No. 2003
ATA Code 32-10
Recurring Inspection

SUBJECT: LANDING GEAR - INSPECTION AND/OR MODIFICATION OF COMPONENTS ON THE MAIN LANDING GEAR STRUT ASSEMBLIES

EFFECTIVITY: BEECHCRAFT Skipper 77, serials WA-1 through WA-312.

REASON: To provide a retainer for the elliptical bushings on the main landing gear strut assemblies.

Figure 1.

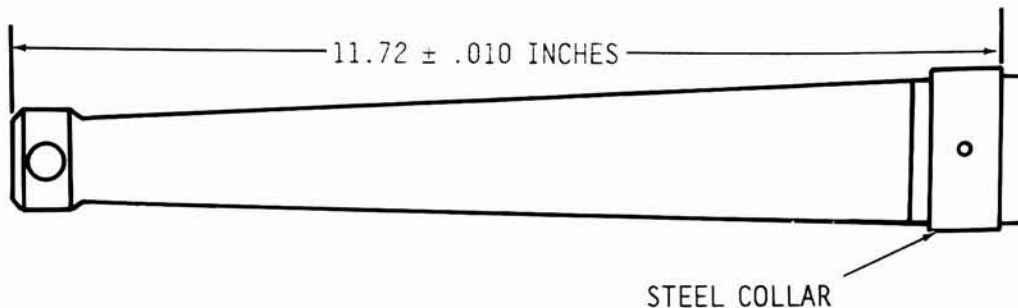
2. Inspect the main landing gear strut for security of the steel collar to the strut (see Figure 1). If the distance between the steel collar and the end of the strut is greater than $11.72 \pm .010$ inches as shown in Figure 1, the collar has separated. If the collar has separated, remove the collar and thoroughly clean the strut at the collar location. Remove all traces of bonding agent with 200 grit sandpaper (obtain locally). If the collar is secure, proceed to step 7.

6. With the strut supported on a bench, locate the collar on the strut in accordance with Figure 1 using care not to contaminate prepared surfaces. Inject P/N EA9309 QT adhesive (mix per manufacturers instructions) into the hole in the collar using a disposable 3 c.c. syringe (obtain locally). Carefully rotate the collar, maintaining the correct collar location, and inject adhesive into the collar a second time. **REPEAT THE PROCEDURE UNTIL CERTAIN THAT NO AIR POCKETS REMAIN INSIDE THE COLLAR.** Re-check the measurements in accordance with Figure 1, and tape the collar in place with masking tape. Allow adhesive to cure 24 hours at room temperature before installing the strut. The use of a heat lamp approximately 12-15 inches from strut is recommended. After curing, remove all excess adhesive from the strut and collar using scotch-brite or equivalent (obtain locally).

Figure 2.

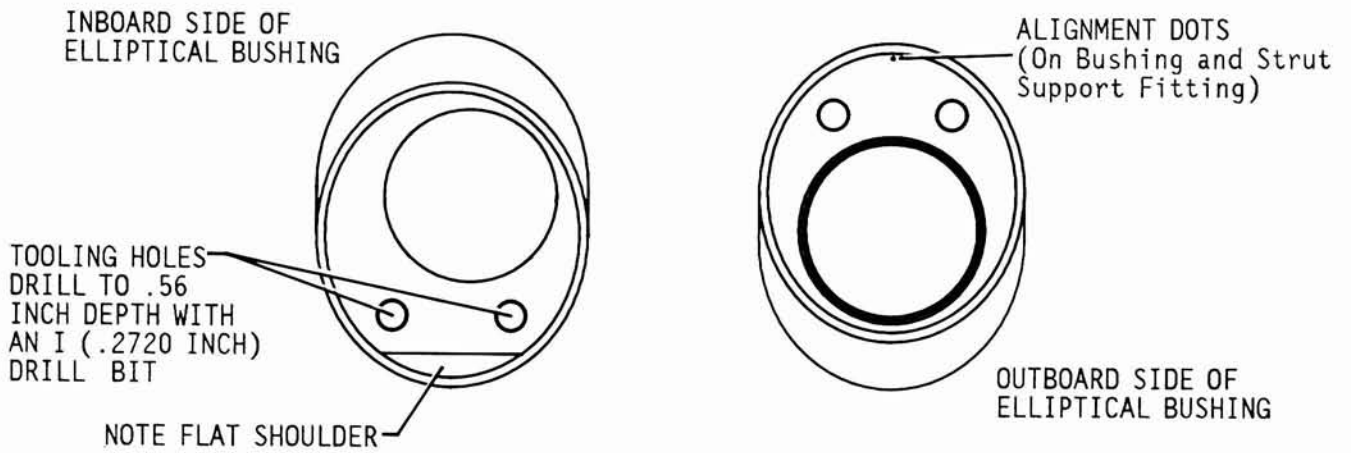
7. Locate the two tooling holes in the inboard side of the elliptical bushing. Drill the holes to a depth of .56 inch with an I (.2720 inch) drill bit. Tap the holes to 5/16-24 thread starting with a tapered tap and finishing with a bottoming tap (refer to Figure 2).

9. Reinstall the landing gear strut after the bonding adhesive (if required in Step 4) has cured. Make certain the alignment dots on the elliptical bushing and strut support fitting (see Figure 2) are aligned exactly. Torque the brace nut (see Figure 3) to 125-150 inch pounds with a spanner wrench while holding the bushing in place. The alignment dots **MUST** align after the brace nut is torqued. Safety wire the brace nut, using P/N MS20995C32 safety wire (obtain locally).

Figure 3.

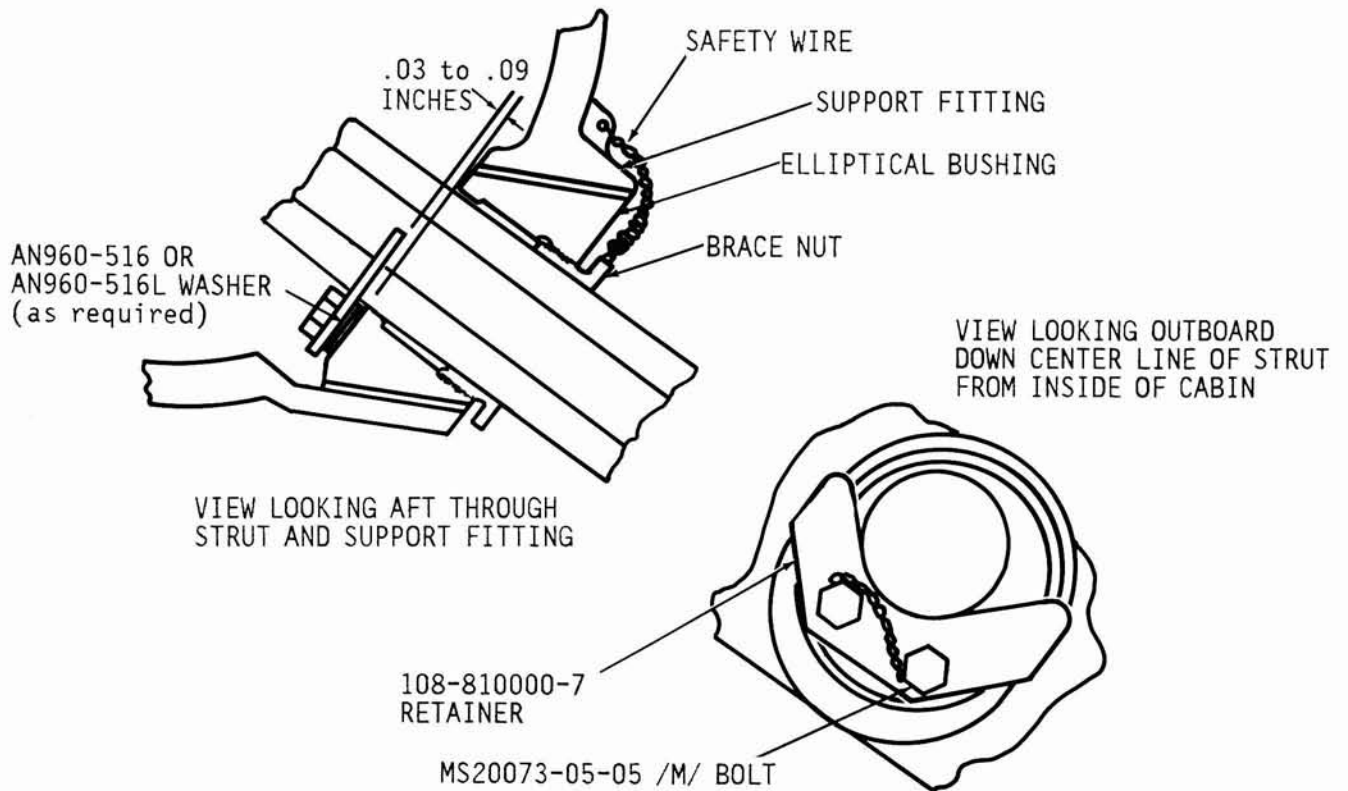
10. Install a P/N 108-810000-7 retainer as shown in Figure 3, using two P/N MS20073-05-05 /M/ bolts. Place P/N AN960-516 or P/N AN960-516L washers between the bushing and retainer as required to maintain a spacing of .03 to .09 inch between the retainer and support fitting (refer to Figure 3). Torque the bolts to 56-78 inch-pounds and safety wire.
